PLANNING COMMISSION MEETING STAFF REPORT

NAME OF PROJECT: Farm Meadows Density Reduction Subdivision

AGENDA ITEM: Preliminary/Final Approval

Subject: Farm Meadows Subdivision – Preliminary / Final Approval

FARM MEADOWS

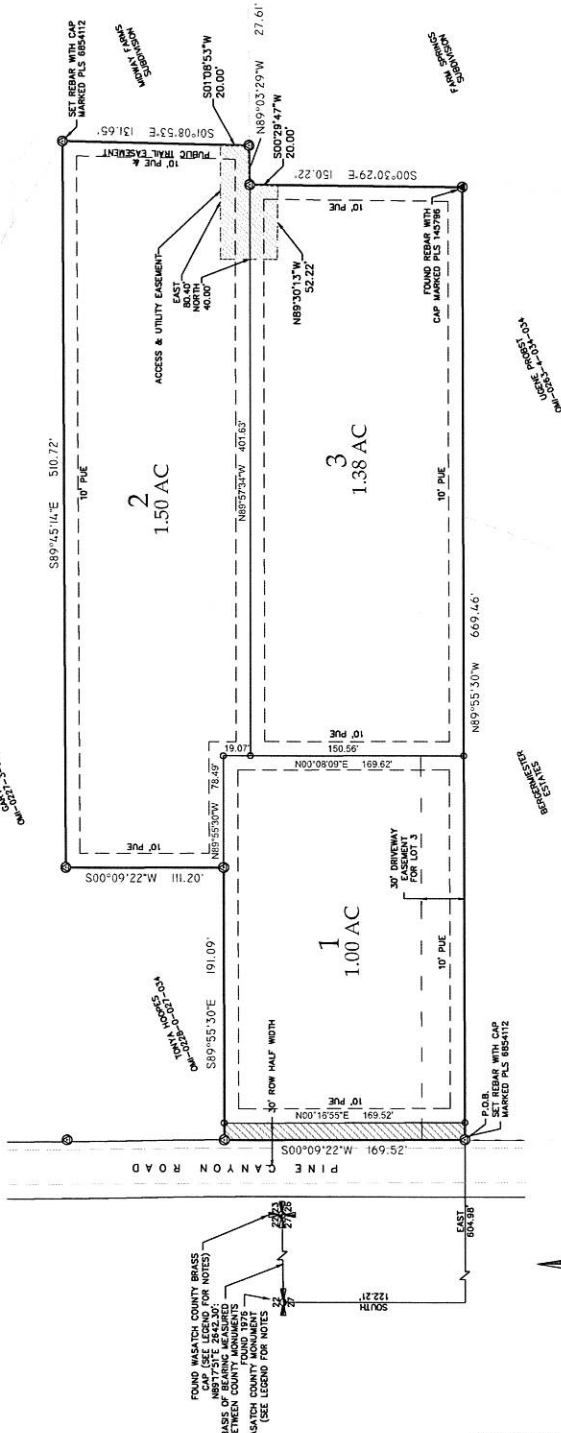
- A 30' driveway easement across lot 1 will need to be placed on the plat map for driveway access to lot 3.
- The right of way half width (28') of the Pine Canyon Road should be dedicated to the city along the frontage of the proposed development.
